Re: Application for Site Plan Review and Special Permit  
102 Howe Street, Ashland Landfill  
Response to Peer Review Comments

AMEC Massachusetts, Inc. (AMEC) is pleased to provide the following responses to comments received from the Town of Ashland's consultant, GCG Associates (GCG), in a letter dated February 8, 2016. GCG's comments are included for reference and AMEC's responses follow each comment.

## ASHLAND LANDFILL 907 KW SOLAR PV DEVELOPMENT ASHLAND, MASSACHUSETTS JANUARY, 2016 ISSUED FOR SITE PLAN REVIEW REVISED FEBRUARY, 2016

TITLE: PROPOSED SITE PLAN

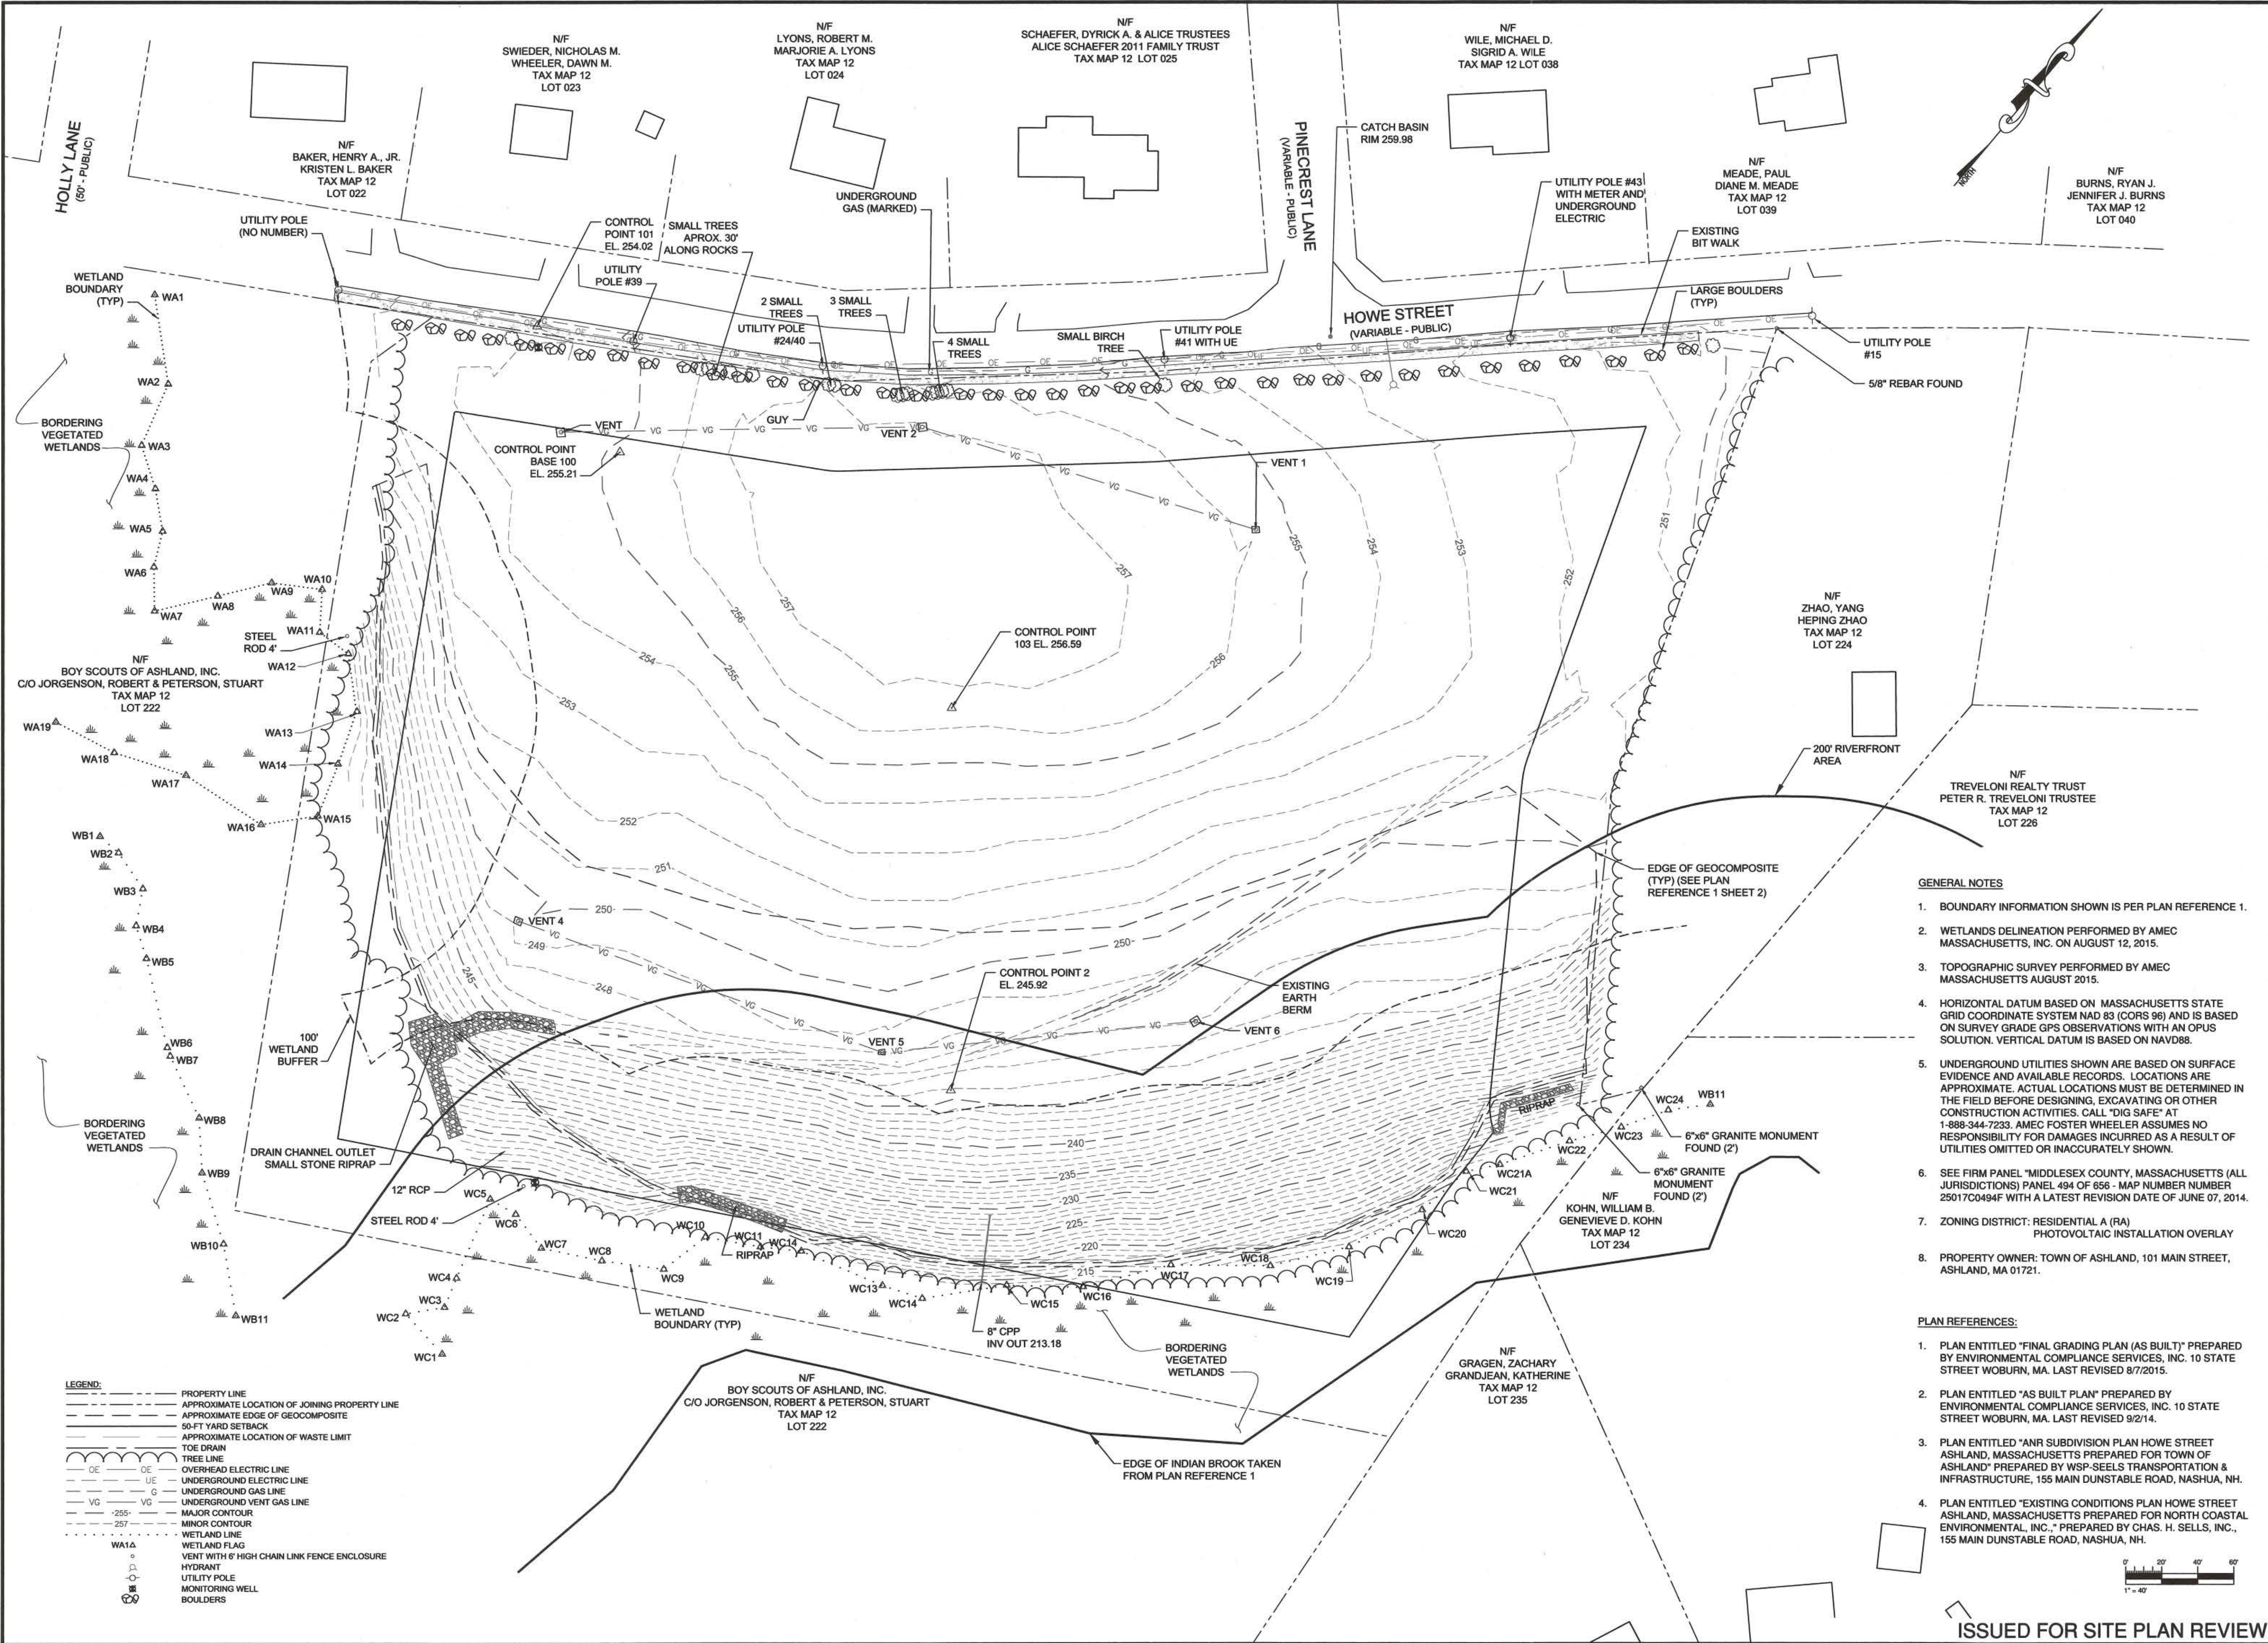
1. The solar panel system footprint is essentially 3.7± acres with maximum dimensions approximately 540'± x 300'±. Two permanent gravel access roads are proposed at the two corners of the Howe Street frontage. Maintenance and emergency access should be considered for the entire grid. Emergency vehicles (fire trucks) may not be able to maneuver in the site.

3. Dimensioning should be shown for the proposed gravel access drives. Information shall be provided to the Planning Board which demonstrates sufficient dimensions of turnaround area for access of emergency and maintenance vehicles. Westerly entrance provides a proposed hammerhead turnaround, while easterly entrance dead ends.

4. Inverts information for the proposed 6" DI culvert should be specified on the plan.

5. Proposed grading for the two gravel access roads should be included on the plan. Grading should also demonstrate sufficient pipe cover over the proposed culvert.

6. Check exist shade areas on Howe Street at Pinecrest Lane.

7. Chain link fence gate location(s), dimensions, specification and detail should be provided on the plan.

**Engineer's response:** The two proposed access roads will accommodate emergency vehicles and fire trucks; however, in order to minimize gravel cover on the vegetative support layer of the cap, larger emergency vehicles will have to back out in reverse in order to exit the site.

**Engineer's response:** Dimensioning for the proposed access roads is shown on Sheet 4, Detail 3. The method used to confirm access road maneuverability was AutoTURN®, a vehicle sweep pass software program which analyzes vehicle access and maneuverability. For the temporary gravel access road, a tractor trailer was analyzed to simulate one-way material deliveries in each direction during construction. Per comments received from the Town during the Planning Board Technical Session, the temporary roadway entrance radii have been increased to provide further maneuverability. For the permanent gravel access roads, maintenance vehicles such as pickup trucks were analyzed. The southern hammerhead turnaround provides sufficient access for a pickup truck, while the northern road is to be used to one-way entrance and exit due to space constraints. Fire trucks or other large emergency vehicles will have to back out in reverse in order to exit the site.

**Engineer's response:** Inverts for the proposed temporary and permanent culverts have been added to the plan. Note #4 has also been added to the plan to read: "Drain pipes under roads to be field adjusted to low point as required to allow drainage from the higher elevation side of the road to pass to the lower elevation side of the road." An additional culvert with its invert information has also been added to the plan at the northern permanent access road to eliminate the possibility of ponding on the landfill cap over the long term. The model used for the stormwater management permit confirms that the previous analysis remains accurate in this area and the culvert has sufficient capacity to accommodate the minimal amount of surface run-off generated in this small drainage area.

**Engineer's response:** Proposed 1' contours for the two permanent gravel access roads have been added to the plan. There is sufficient cover over the proposed DI culverts which are capable of withstanding heavy traffic.

**Engineer's response:** There is one rack proposed to encroach into the existing shade area of the nearby utility pole. This rack was recently relocated from the east side to the west side in order to facilitate the perimeter fence construction.

**Engineer's response:** The proposed chain link fence and gate locations are shown on the site plan on Sheet 3. Additional fence and structural details with dimensions have been added to plan set on a new Sheet 8.
